Comments on the Applicant's D8 and D9 submissions

This document sets out the comments on the Applicant's Deadline 8 (D8) and Deadline 9 (D9) submissions by Cambridgeshire County Council (**CCC**), Huntingdonshire District Council (**HDC**) and South Cambridgeshire District Council (**SCDC**) (together, the **Councils**). The tables below set out the document in question that the Councils are commenting on, together with the relevant paragraph or reference number.

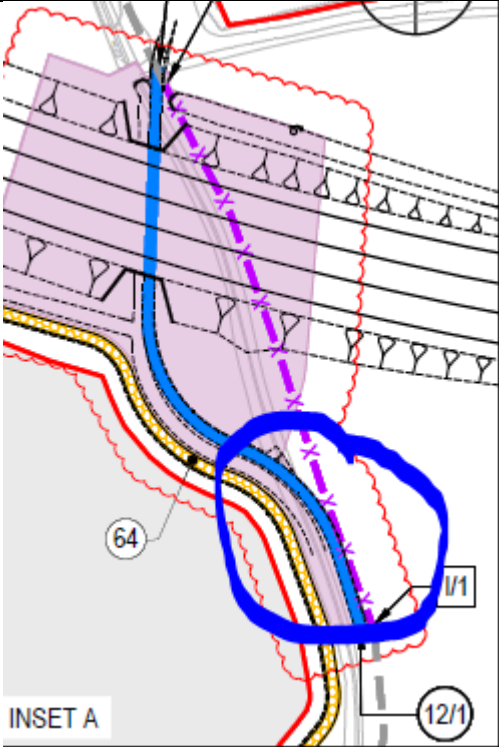
<p>REP9-002 and REP9-003</p>	<p>Sheets 6,8, 9 and 14</p>	<p>The Councils have previously stated that the NMUs here should be created for equestrian usage as well, not just as 'cycle track'. The Councils understand that this point is agreed by the Applicant in respect of Sheets 9 and 14.</p>

Public Rights of Way cannot be created within the boundary of another class of highway as is currently indicated by the provision 9/13 to 9/14 and from 9/12 to the edge of the highway boundary (indicatively shown by the yellow line on the extract above) and between 14/4 and 14/14 (extracts above for ease).

The Councils are advised by the Applicant that the Applicant intends to update the dDCO at Deadline 10 to include a new definition of “bridlepath” as follows:

<p><i>"bridlepath" means a way constituting or comprised in a highway over which the public have a right of way on pedal cycles (other than pedal cycles which are motor vehicles within the meaning of the Road Traffic Act 1988), on foot and on horseback or leading a horse, but no other rights of way;</i></p> <p>This definition should be used as follows:</p> <ul style="list-style-type: none"> - Article 14(7) of the dDCO should be updated to refer to bridlepaths as well as footpaths, cycle tracks, footways and bridleways; - Article 14(17) of the dDCO should be updated to refer to bridlepaths as well as footpaths, cycle tracks, footways and bridleways; - Part 7 of Schedule 3 of the dDCO should be updated as follows: <ul style="list-style-type: none"> o the wording <i>"60 metres of bridleway from point 9/13 to 9/14 as shown on Sheet 9 of the streets, rights of way and access plans"</i> should refer to bridlepaths rather than bridleway; o the wording <i>"bridleway from point 9/12 to point 10/1 as shown on Sheets 9 and 10 of the streets, rights of way and access plans"</i> should be updated to refer to bridlepath between point 9/12 and a new reference point at the edge of the highway boundary, with the reference to bridleway retained after this new reference point to 10/1, with consequential updates made to the relevant lengths; and o the wording <i>"cycle track from point 14/4 to point 14/14..."</i> should be updated to refer to bridlepath rather than cycle track in respect of this section, with consequential updates made to the relevant lengths; - the heading of Part 7, Schedule 3 of the dDCO should be updated to refer to bridlepaths as well as footpaths, cycle tracks, footways and bridleways; - the introductory text at (b) in Schedule 4 should be updated to refer to bridlepaths as well as footpaths, cycle tracks, footways and bridleways; - Part 2 of Schedule 4 of the dDCO should be updated as follows: <ul style="list-style-type: none"> o the wording <i>"60 metres of bridleway from point 9/13 to 9/14 as shown on Sheet 9 of the streets, rights of way and access plans"</i> should refer to bridlepaths rather than bridleway; o the wording <i>"bridleway from point 9/12 to point 10/1 as shown on Sheets 9 and 10 of the streets, rights of way and access plans"</i> should be updated to refer to bridlepath between point 9/12 and a new reference point at the edge of the

<p>highway boundary, with the reference to bridleway retained after this new reference point to 10/1, with consequential updates made to the relevant lengths; and</p> <ul style="list-style-type: none"> ○ the wording “<i>cycle track from point 14/4 to point 14/14...</i>” should be updated to refer to bridlepath rather than cycle track in respect of this section, with consequential updates made to the relevant lengths; and <p>- Sheets 9 and 14 of the Streets, Rights of Way and Access Plans should be updated to refer to “bridlepath” in respect of the areas noted in the above amendments.</p> <p>The Councils expect that the Applicant would then use its powers under Article 55 of the dDCO so that the legal effect of the new bridlepath classifications (i.e. the prohibition of vehicular traffic) can be enforced under the Road Traffic Regulation Act 1984. The Councils would expect that any costs incurred by the LHA in this regard would be recovered from the Applicant.</p>
